Proposal for BDDM – Stem Steel
 Prepared by Craig Shike & Bill Bennett, October 23, 2009

Modify Figure 1.1.13.3A as follows:

Figure 1.1.13.3A

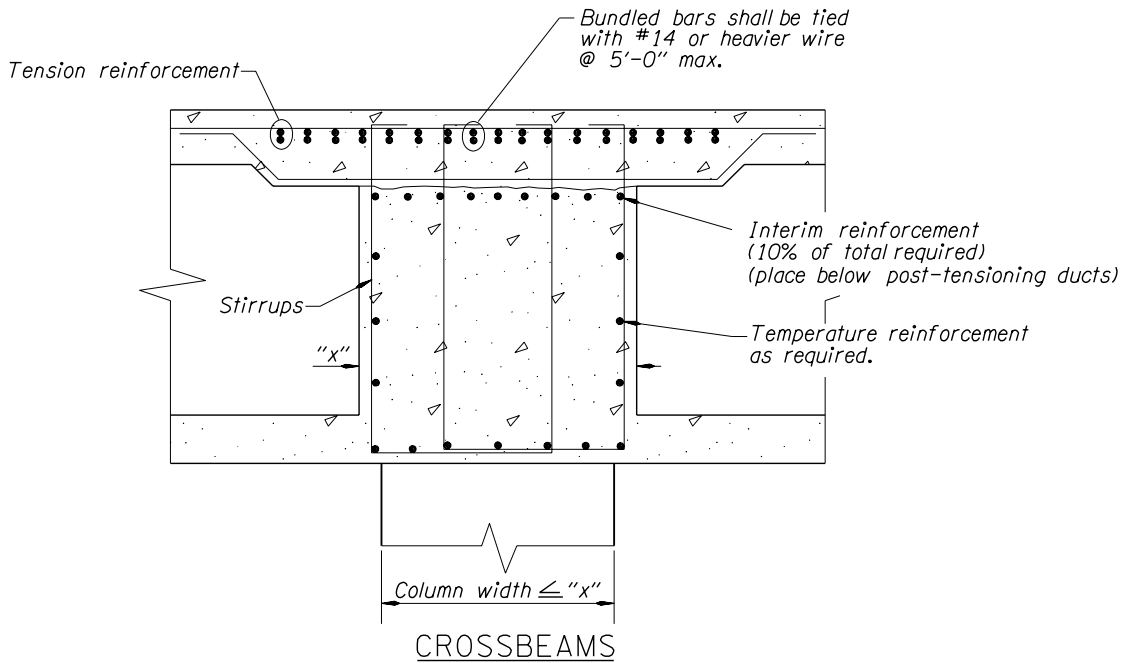
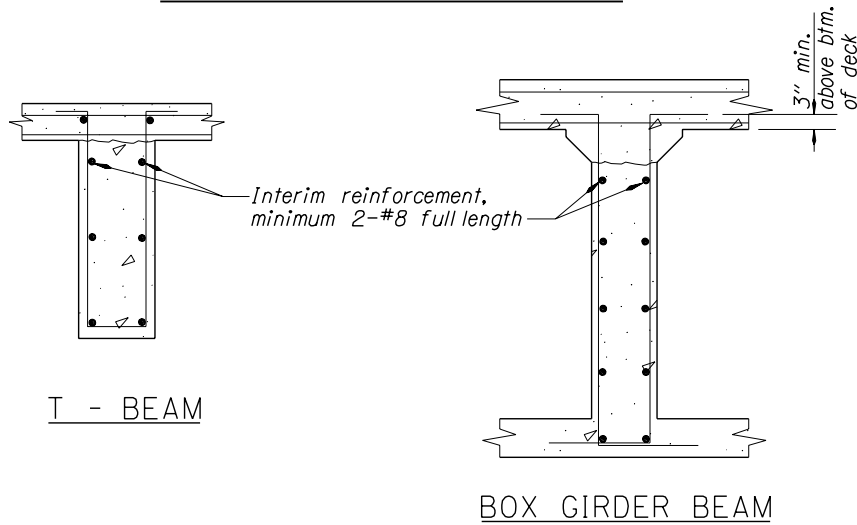
The box girder beam stirrup detail has been revised to match changes previously made to precast girders as shown on Figure 1.1.14.2C. This change will improve constructability of box girders.
